MP10_0154 Residential Development at Edwin, Bennett, Northcote and Hilly Street, Mortlake

Thank you for your letter requesting comment on the proposed residential development at the above address. Sydney Water has reviewed the proposal and provides the following comments for the Department's consideration.

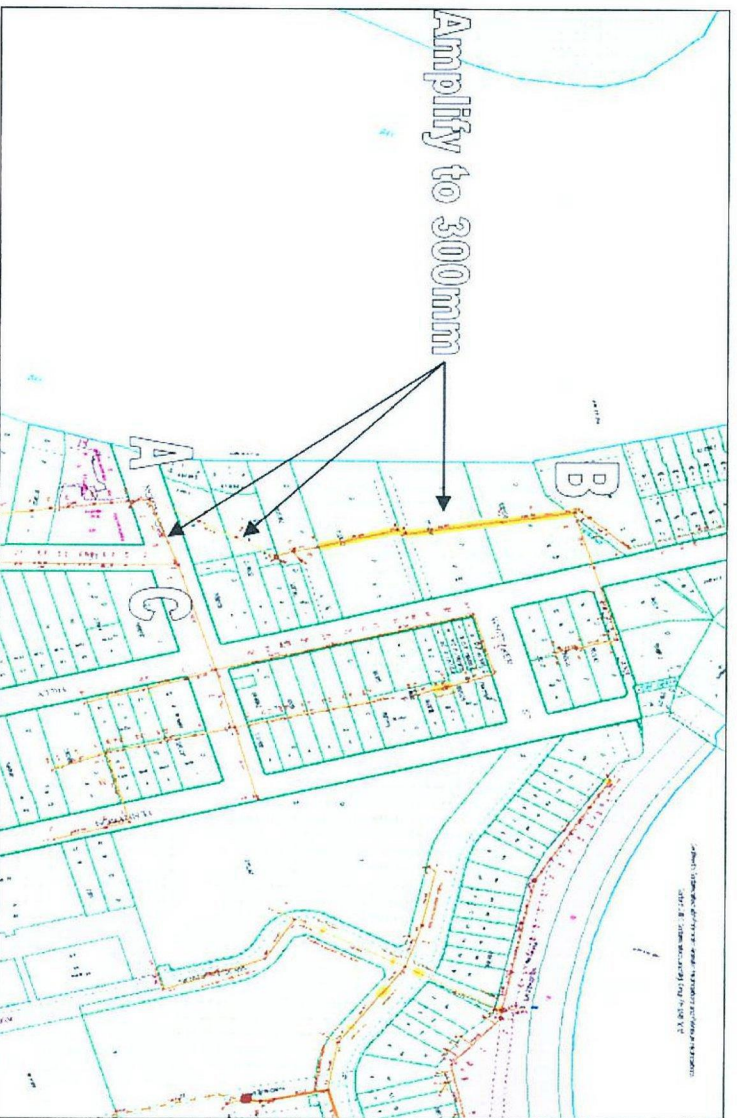
The proposed 9 storey building in Precinct 2, fronting Hilly Street, requires a 200mm drinking water main extension from the intersection of Edwin Street and Tennyson Road to link up with the existing 150mm drinking water main in Hilly Street that fronts this development, shown as **A to B** on the below diagram.

The existing 150mm drinking water main in Bennett Street needs to be extended to front the proposed development at 16-18 and 20-22 Bennett Street shown as **C to D** on the below diagram. This section of the development is called Site 2, Precinct 5 and has two proposed 4 storey buildings.

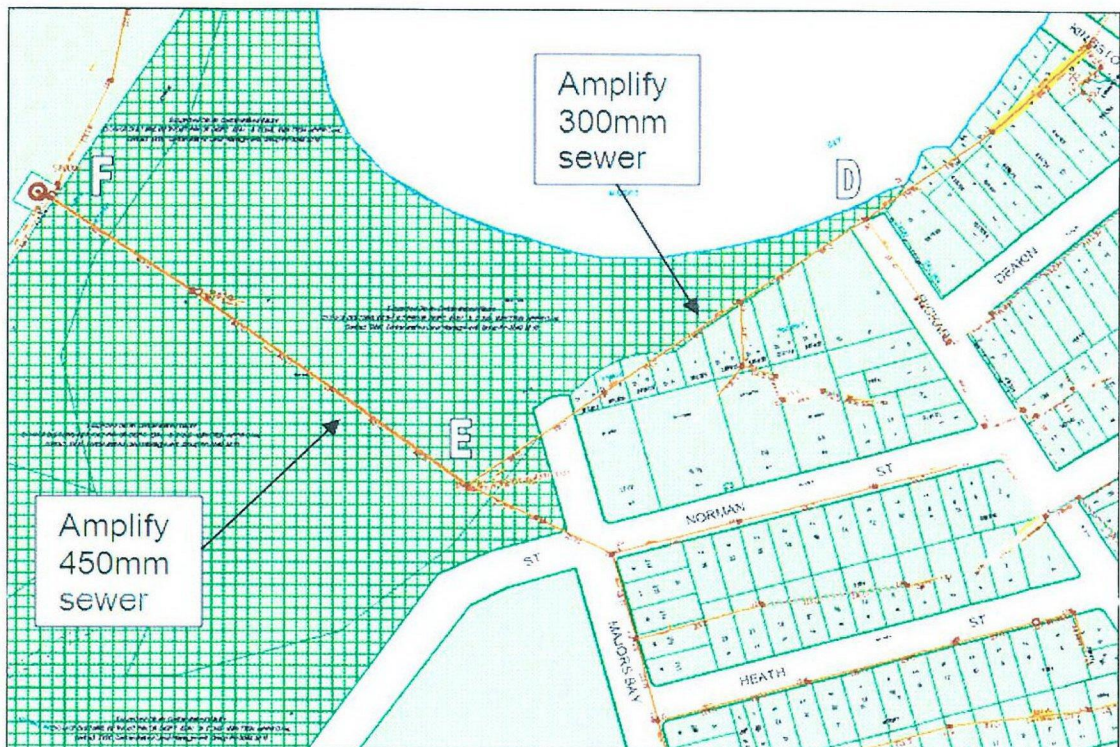
The existing 225mm sewer shown on the below diagram needs to be amplified to 300mm sewer as A to B being 217 metres in length and A to C being 42 metres in length.

Additional to the above developer requirements, this development will exceed wastewater capacity downstream as shown in the Concord West SCAMP Report that has identified that SPS 90 has insufficient storage capacity for future development and the sewer pipelines upstream and downstream of SP 090 has insufficient capacity under future conditions.

The dry weather storage at SP 090 needs additional storage to cater for this development in addition to the 64 cubic metres that was already identified in the SP 090 Storage Capacity report. The existing 450mm and 300mm sewer from Rickard Street to SP 090 will need to be amplified as shown as D - E - F on the below diagram.

There is no Sydney Water work program for the above amplifications. The SP 090 pump rate is to **remain** as the **current 122 l/s** as these pumps should be increased but cannot due to downstream pipe restrictions.
